Ordinance No. 021164

approving the C-P Development Plan of Eastport Plat 1-A-3; approving less stringent landscaping requirements; and fixing the time when this ordinance shall become effective.

TO: City Council
FROM: City Manager and Staff
DATE: November 11, 2011
RE: Eastport Plat 1-A-3 C-P Plan

**AGENDA REPORT
PLANNING AND ZONING COMMISSION MEETING
November 10, 2011**

**C-P CONCEPTUAL STORM WATER PLAN
 EASTPORT PLAT 1-A-3**
 COLUMBIA, MISSOURI

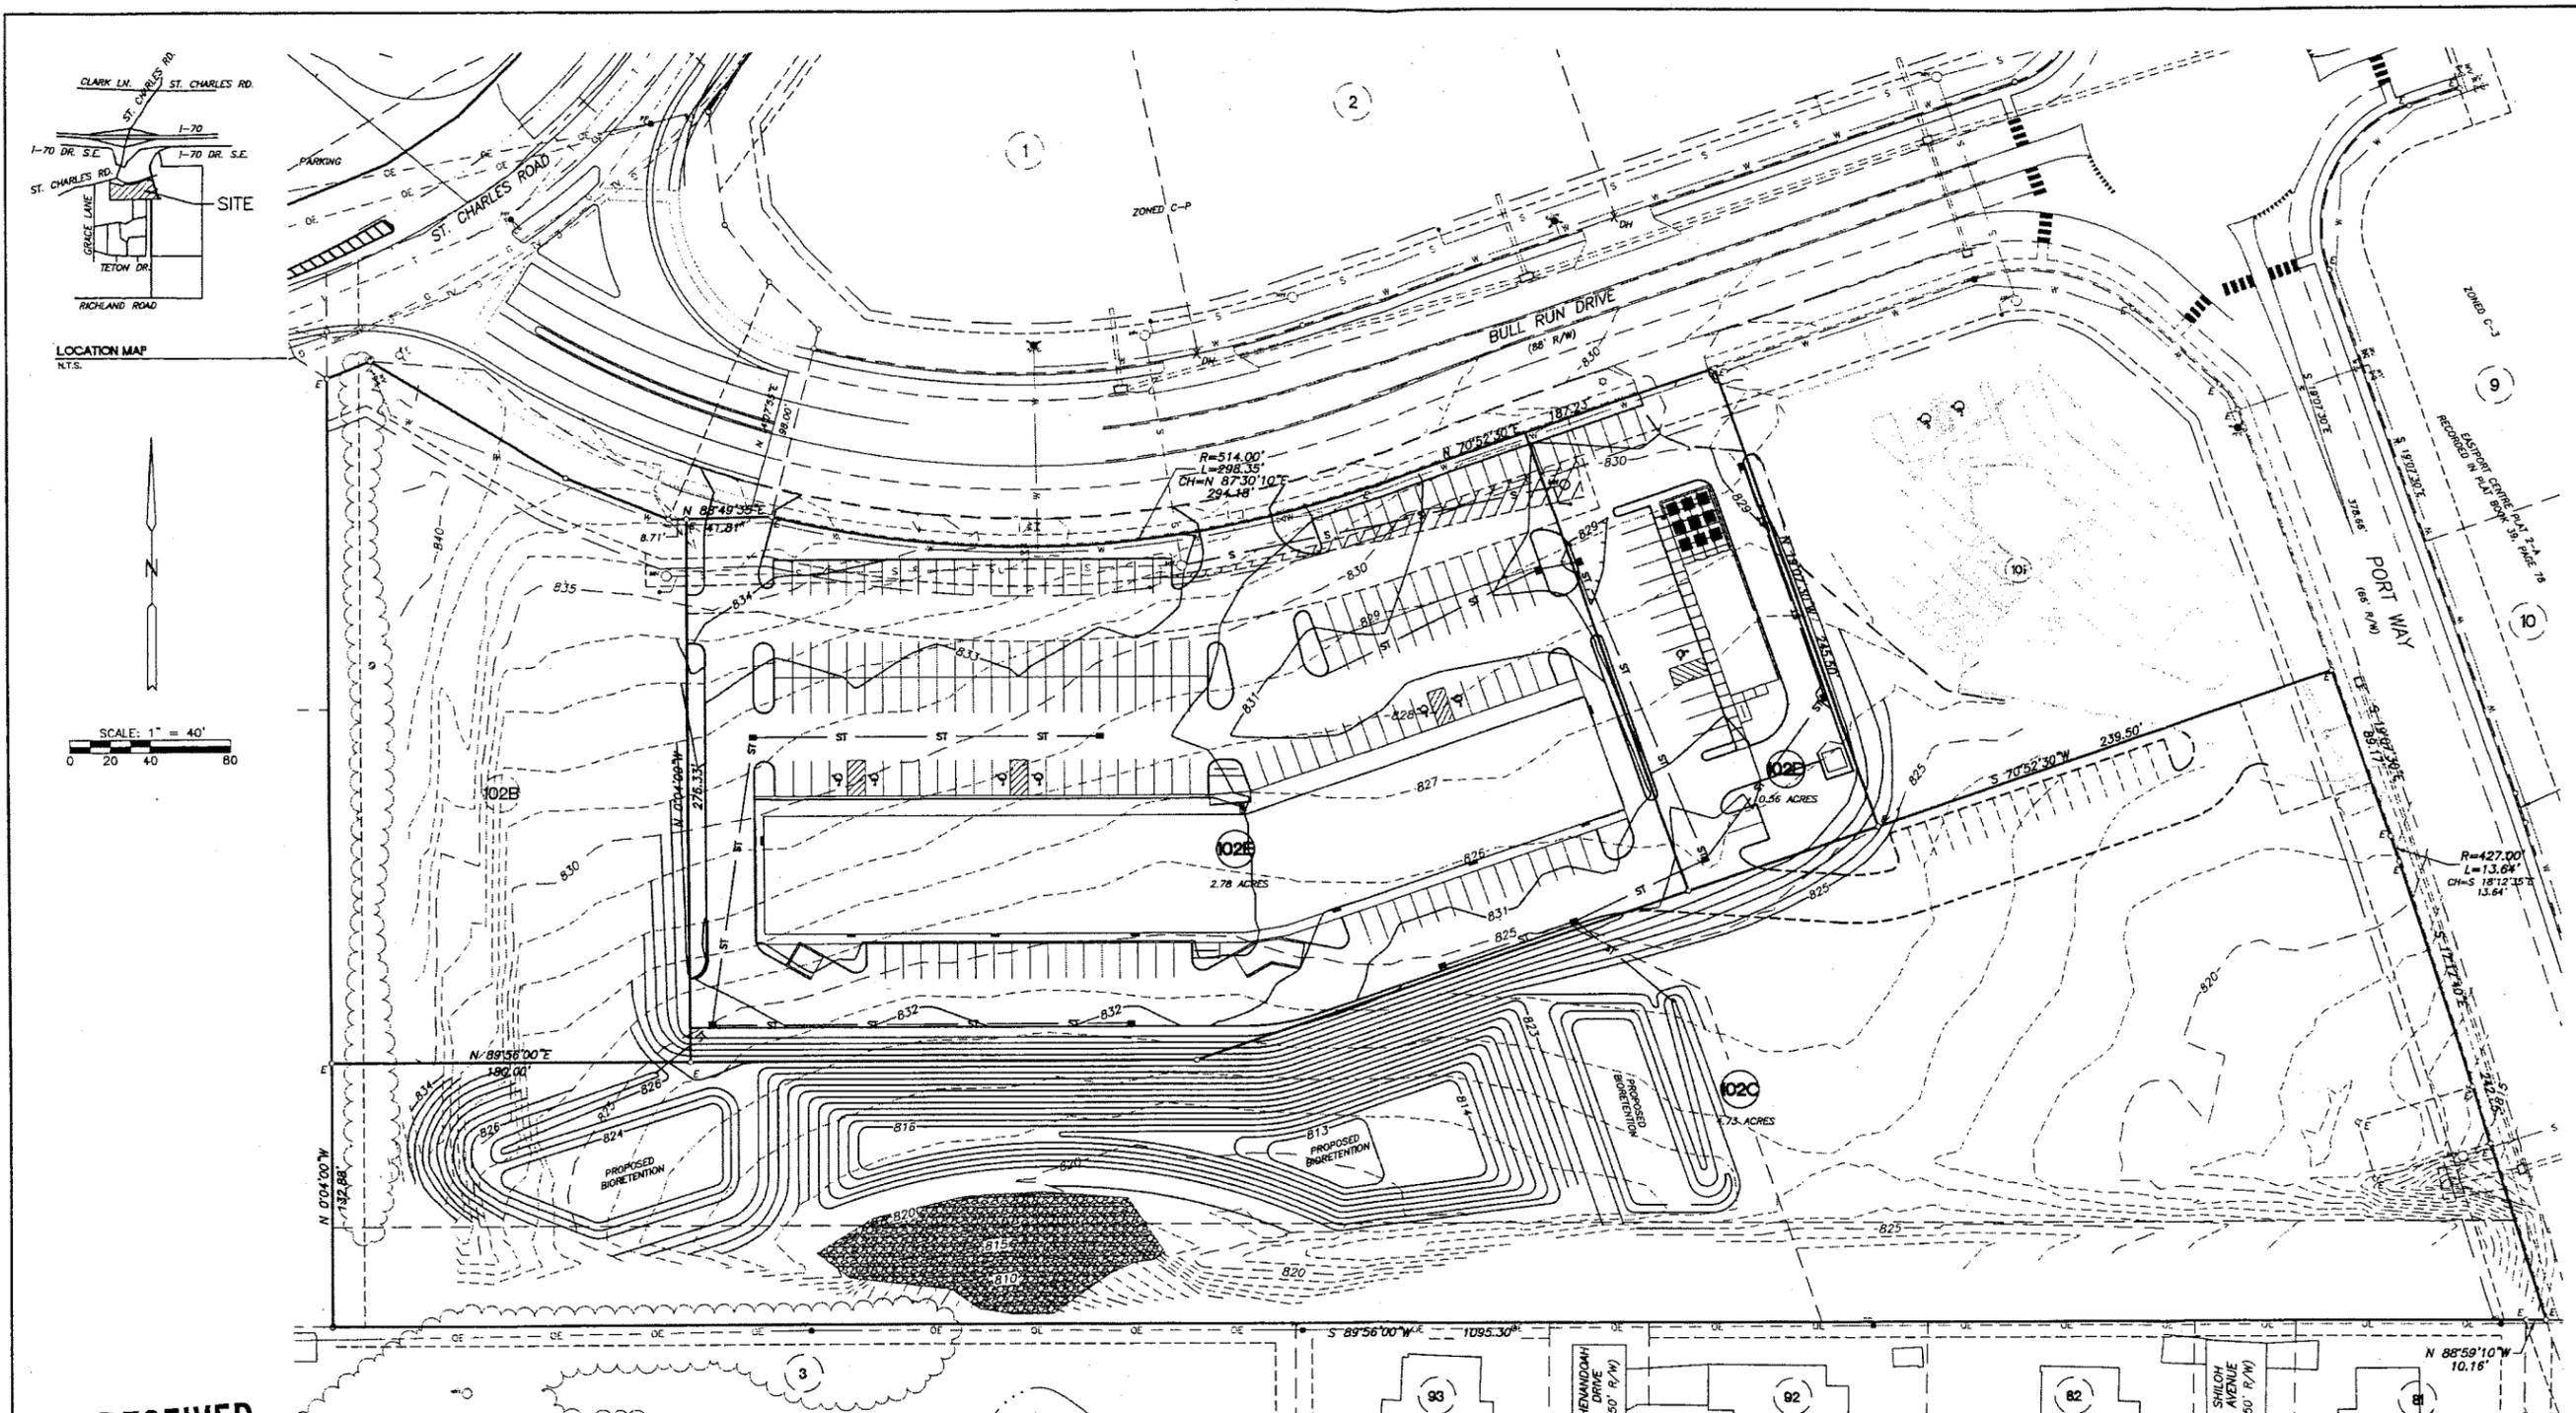
MR. LEE: Yeah. Staff is not concerned at all about the stormwater runoff onto those residences south of --

MR. MACINTYRE: No. We're not concerned about that. The new stormwater regulations -- I shouldn't say new anymore. They've been around for a few years now. But the stormwater regulations that we have in place at this time are supposedly -- require that there is no greater runoff from the site than -- post development from predevelopment. And so the -- you know, the intent of regulations and if things work as they are supposed to, there would not be any additional runoff onto those residents to the south.

MR. VANDER TUIG: The buyer retention, does that meet the stormwater requirements for both, the other two lots?

MR. MACINTYRE: According to Public Works, yes, at this point, at least conceptually. And I have not seen any calculations, but I wouldn't be qualified to interpret them anyway, so we have had the plan bounced -- or reviewed by Public Works and they have signed off on it at this point.

**C-P CONCEPTUAL LANDSCAPING PLAN
EASTPORT PLAT 1-A-3
COLUMBIA, MISSOURI**

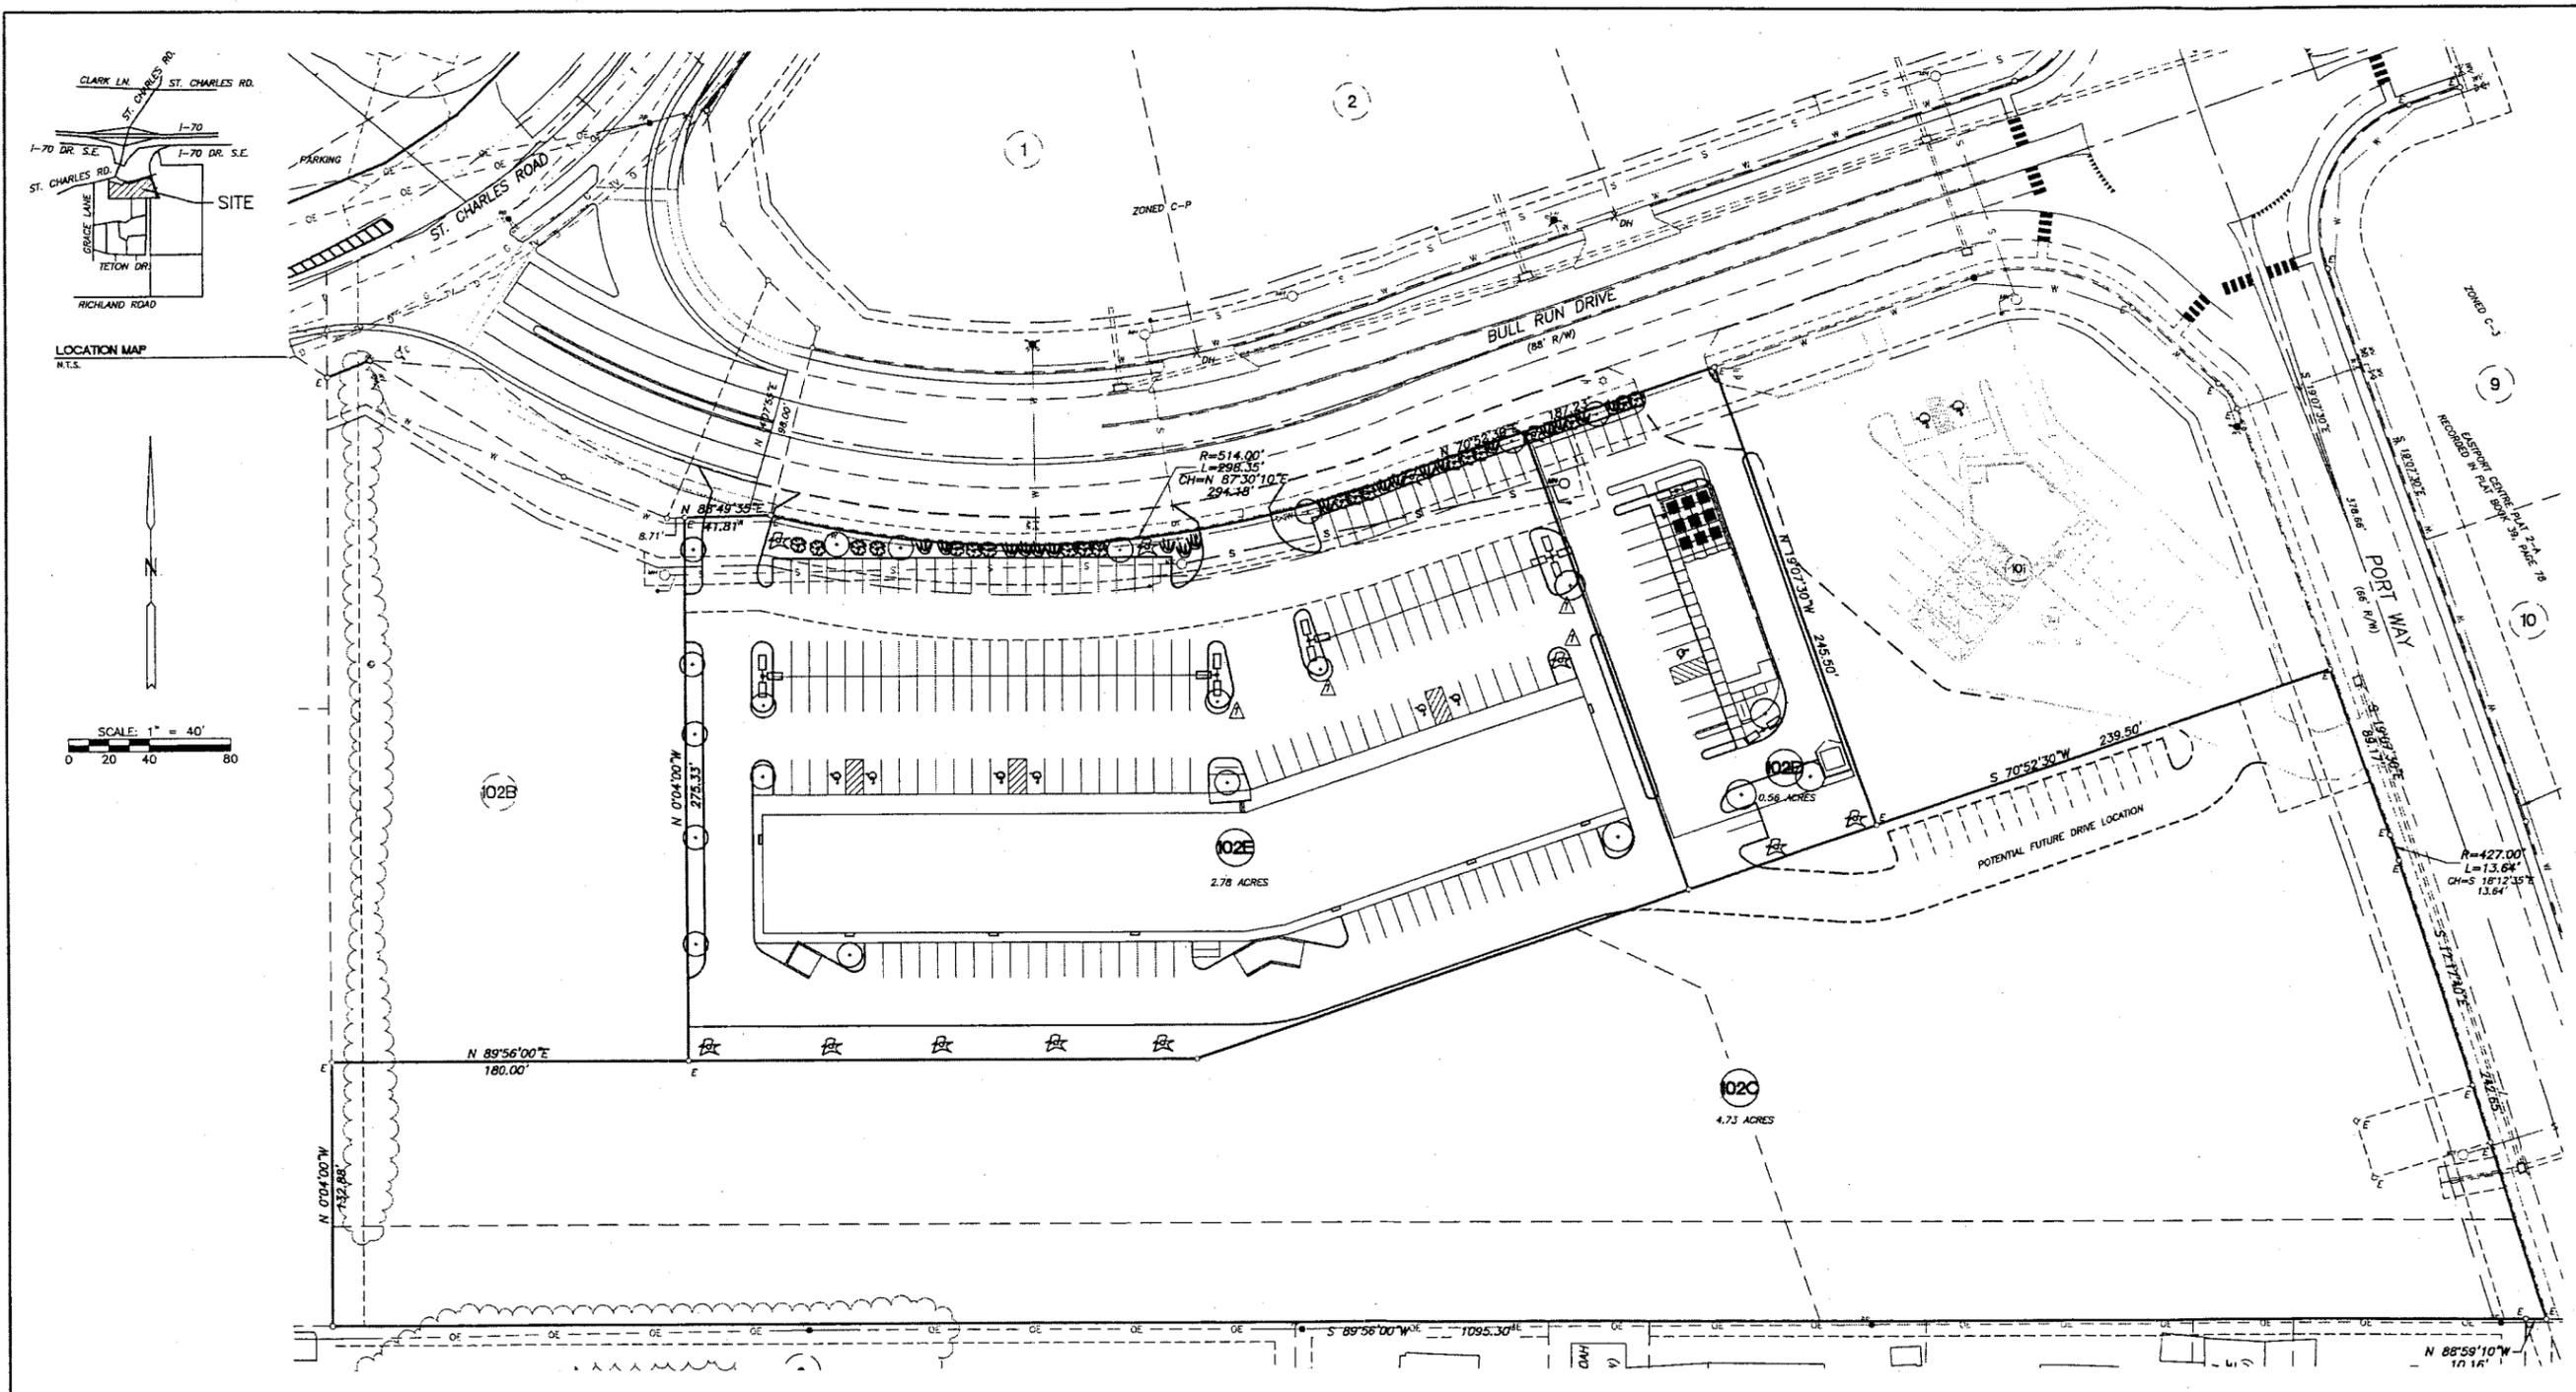
The applicant requests variance from Section 29-25(e)(1), which requires each parcel to independently meet the 15% minimum open space requirement. This restriction would prevent the open space on Lot 102C designated for common storm water retention serving the entire planned development area, from being counted toward the open space requirements on Lots 102D and 102E. The applicant is requesting flexibility to allow a portion of the open space on Lot 102C to be counted toward Lots 102D and 102E to meet open space requirements.

This C-P plan creates a large storm water management tract adjacent to Lot 102 E. As proposed, Lot 102 E contains 11.4% landscaping (3.6% short of the required 15%). However, the storm water management tract contains well over the 4400 sf. of landscaped area needed for the required 15% landscaped area on Lot 102 E. All of the remaining landscape ordinance requirements for screening and parking lot shading will be met with the proposed plan. In addition, the proposed storm water management approach to this project provides a larger buffer between the commercial uses and residential uses (to the south).

- IMPERVIOUS AREA: 107,322 S.F.
PARKING: 81,534 S.F.
LANDSCAPE AREA: 13,868 S.F.
- MIN. NUMBER OF TREES REQUIRED AS PER SECTION 29-254(1) LANDSCAPED AREA= 11.4x<15x (SEE NOTE 5)
 (1) N/A
 (2) 389 L.F. WITHIN 20' OF R/W
 (3) 81,534 S.F./4500= 18 TREES
 (4) N/A
 (5) 9 OF 27 TREES (MEDIUM TO LARGE)
- ALL DISTURBED AREAS SHALL BE SEEDED AND MULCHED AFTER CONSTRUCTION.
- THERE IS NO CLIMAX FOREST ON THIS SITE.
- APPROXIMATELY 4400 S.F. OF LOT 102C ADJACENT TO LOT 102E WILL BE LANDSCAPED TO MEET THE 15% REQUIREMENT FOR THE ENTIRE TRACT.
